**FAÇADE REPAIRS FOR KING BUILDING AND MEMORIAL HALL
UNC CHARLOTTE
SCO ID 23-25933-01B; SKA PROJECT NO. 230392.4**

ADDENDUM NUMBER 1

**UNC CHARLOTTE KING BUILDING AND MEMORIAL HALL
BUILDING ENVELOPE REPAIRS
CHARLOTE, NORTH CAROLINA
SKA PROJECT NO. 230392.4**

S4.1

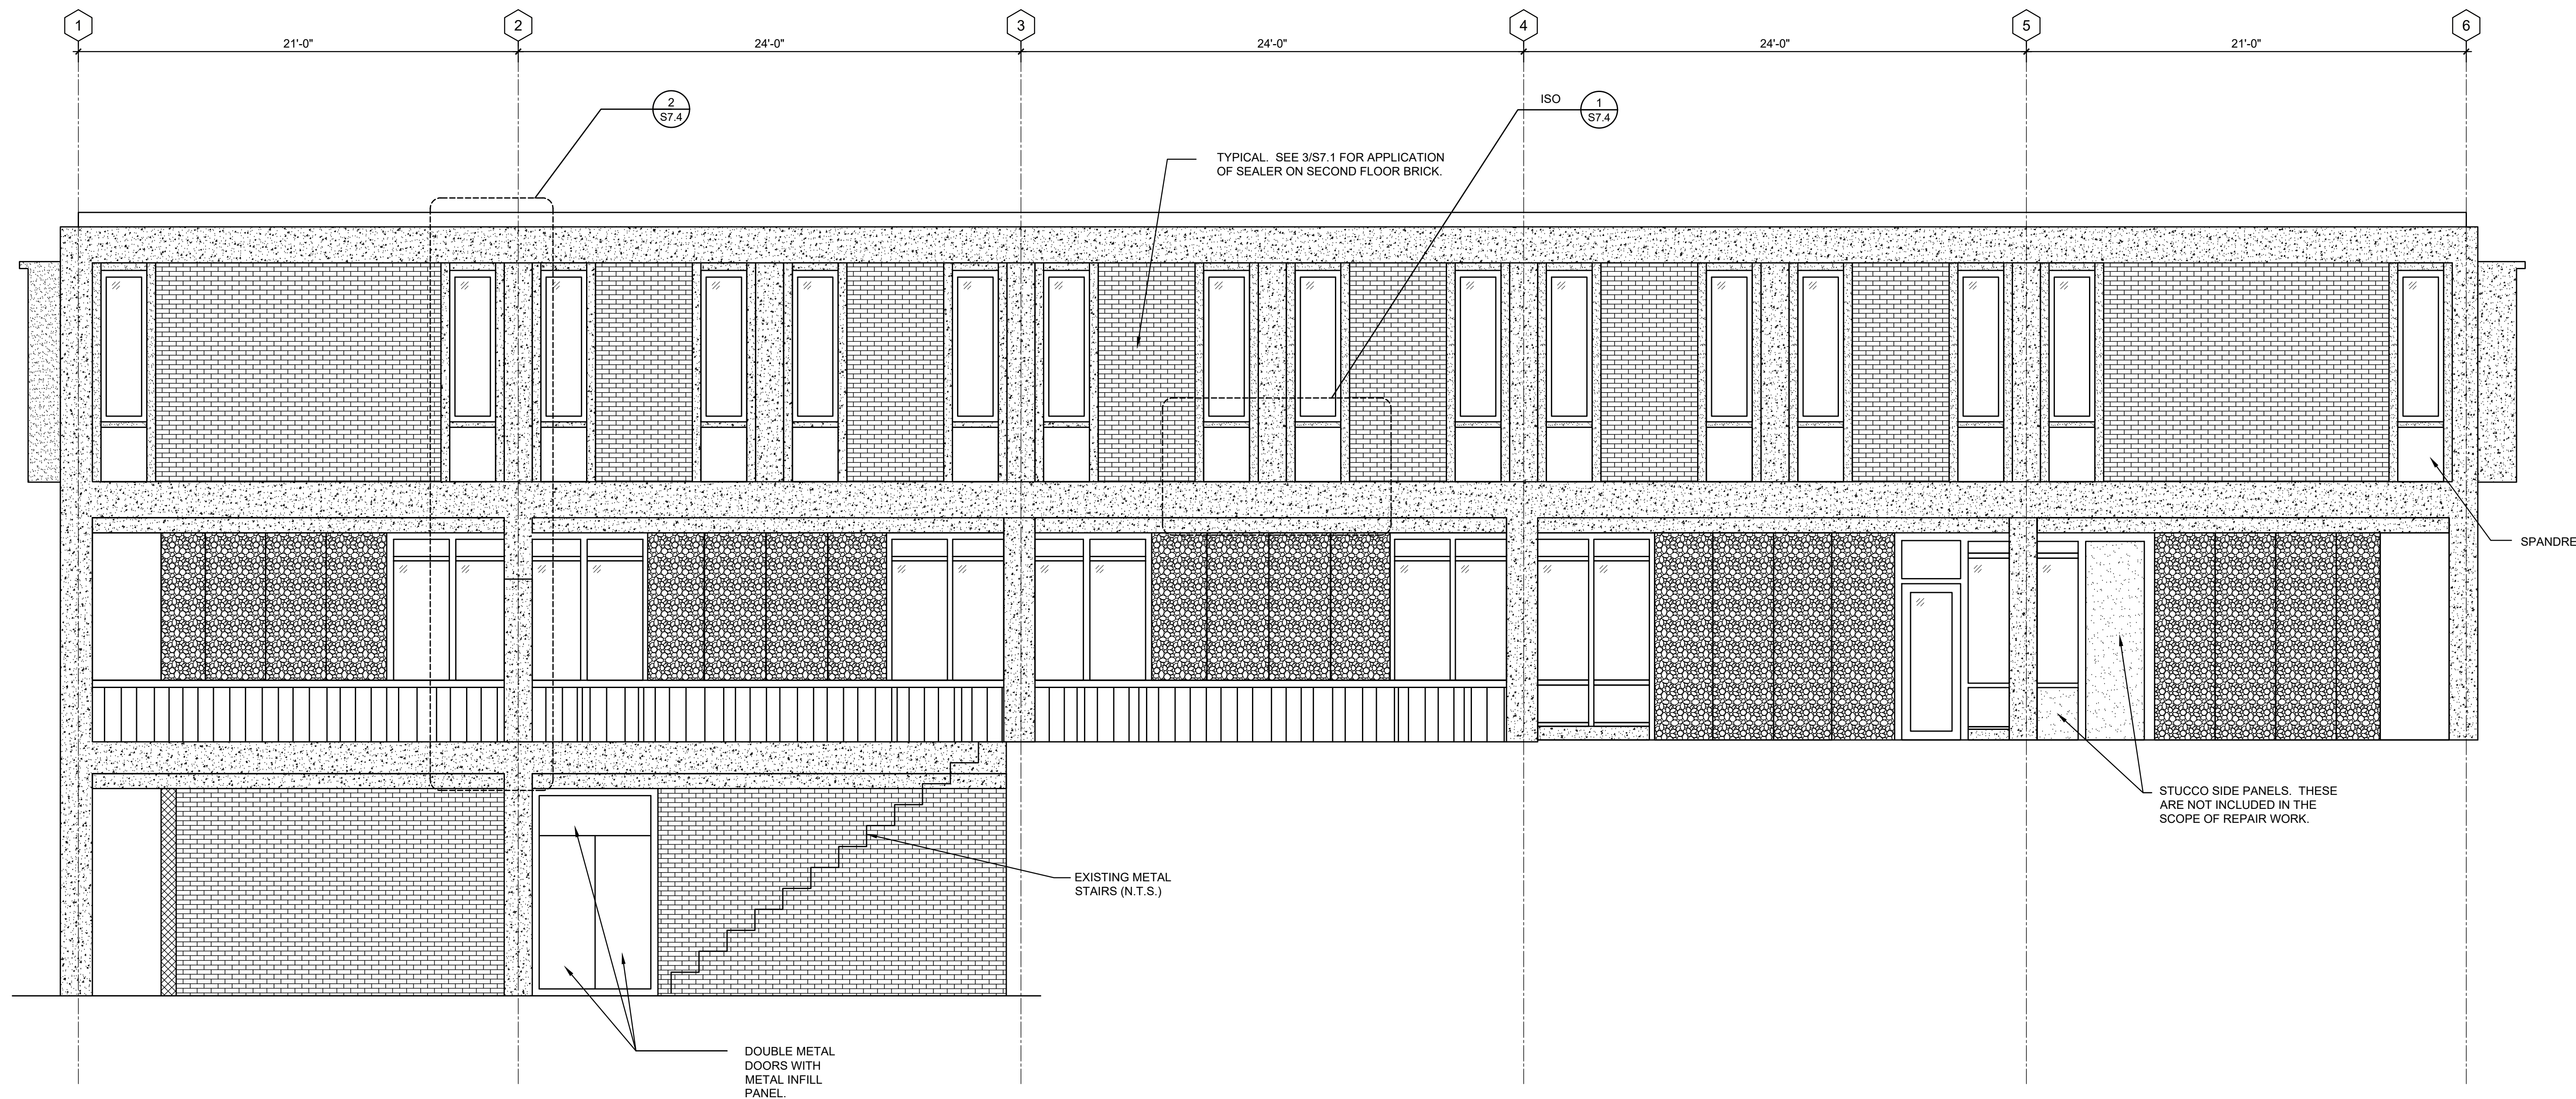
17. The UES Report indicates that there is approximately 5000 sf of Cementitious overlay/Exterior coating that contains asbestos (CO 1) and 50 sf of Cementitious overlay/Side door panel that contains asbestos, the drawings do not indicate where these areas are located. Can this be clarified? The cementitious overlay is installed over all exposed cast-in-place concrete elements. The side door panel occurs on the south elevation of king building but are not in the scope of work (Also see Question 18 below). See revised Drawing Sheet S4.1 attached.

18. Are the stucco clad side panels on the South elevation of King Building included in the scope of work? At this time the stucco clad side panels on the South elevation of the building are not in the scope of repair work. See revised Drawing Sheet S4.1 attached.

1. Drawing Sheet S4.1: Indicate location of stucco side panels and that not in scope of repair work.
2. Detail 4/S7.4: Revised dimensions of cutout from 3" to 4" and added 1-1/2" minimum depth requirement.
3. Detail 5/S7.4: Revised dimensions of cutout from 3" to 4" and added 1-1/2" minimum depth requirement.

HANDRAIL POST REPAIR IN CONCRETE - ISOMETRIC

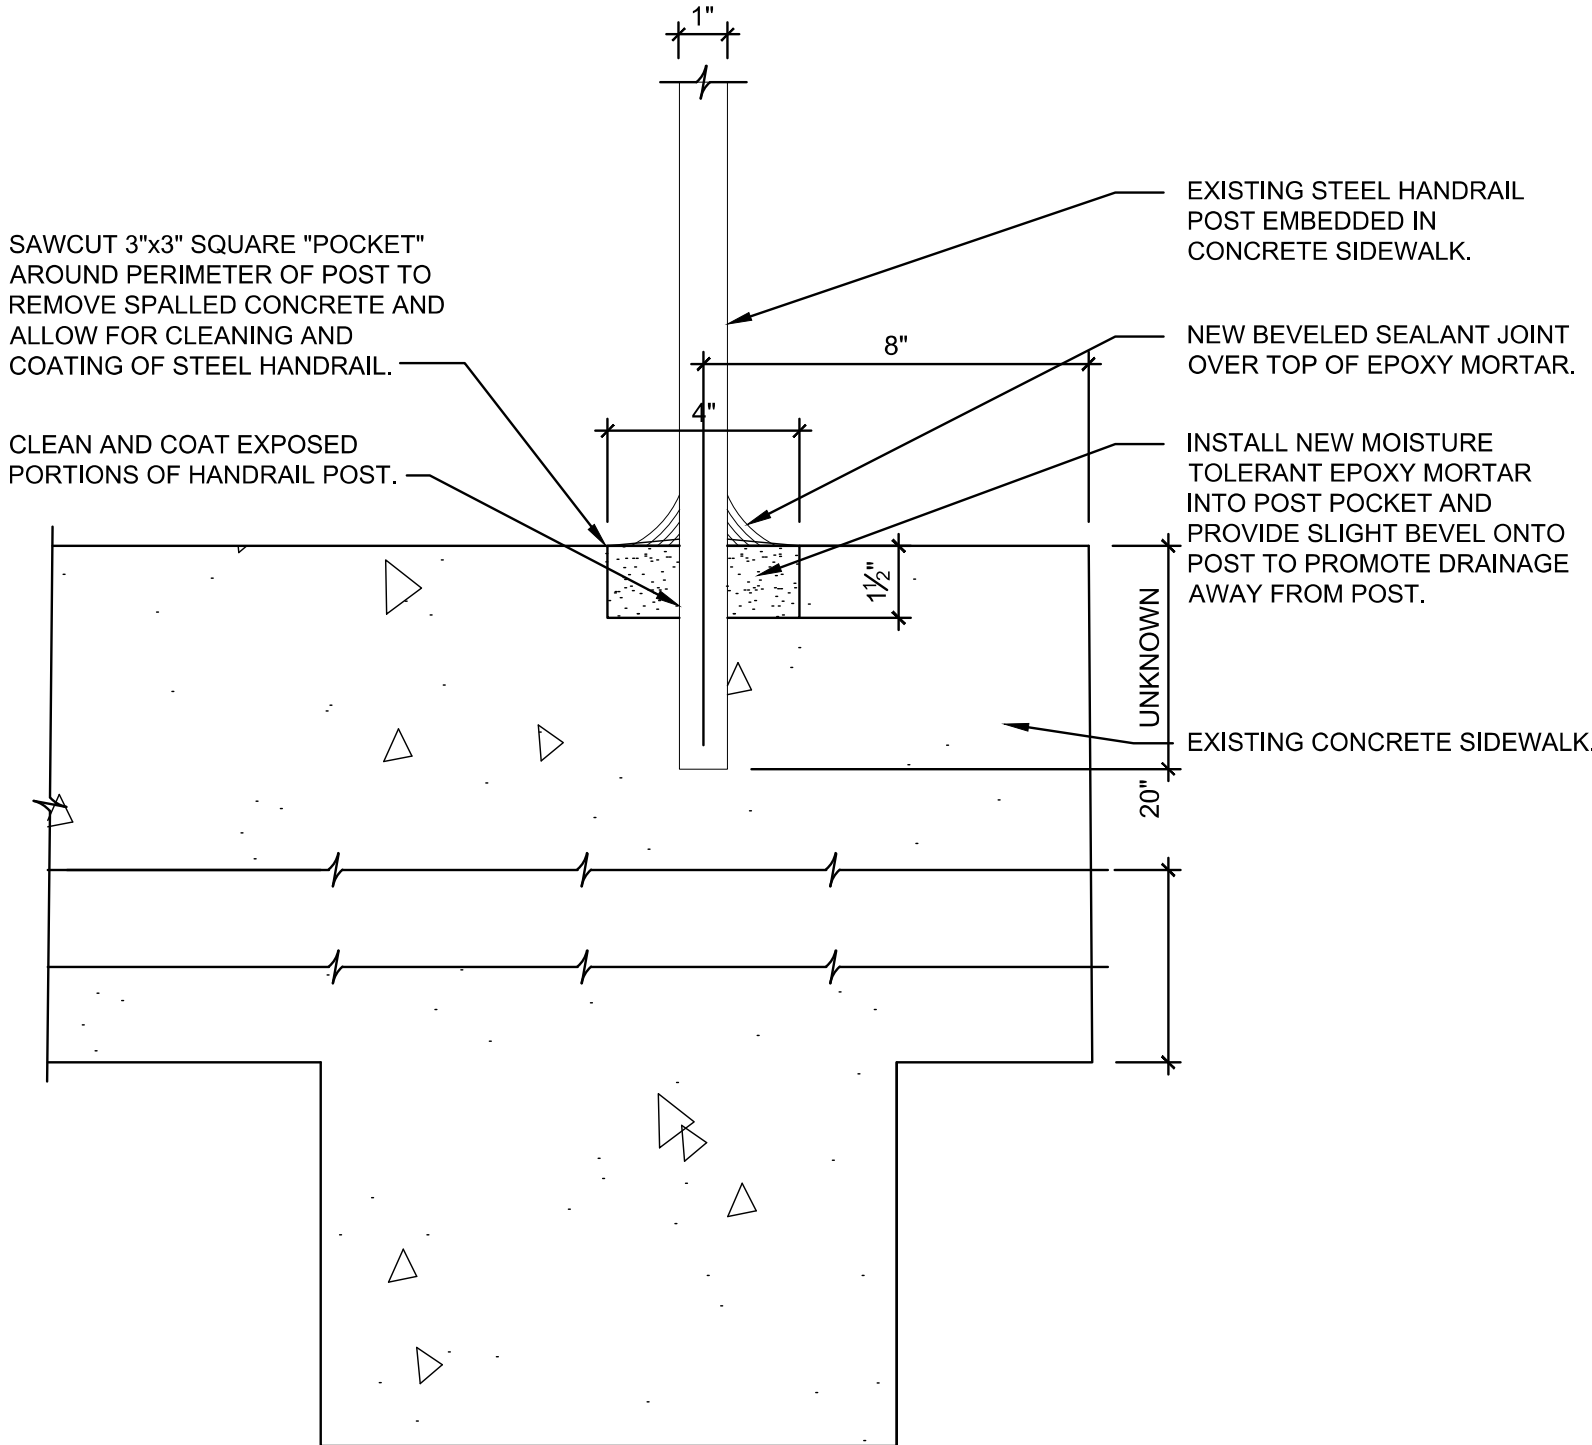
19. Detail 5/S7.4 indicates the size of the epoxy mortar spall repair at individual post pockets but not the depth. How deep are these repairs? Minimum 1-1/2" depth, however, the depth of the removal will vary and Contractor should remove any deteriorated concrete. In addition, SKA is modifying the detail to show a 4" x 4" repair due to grinder wheels typically having 4" diameter blades. See Revised Detail.
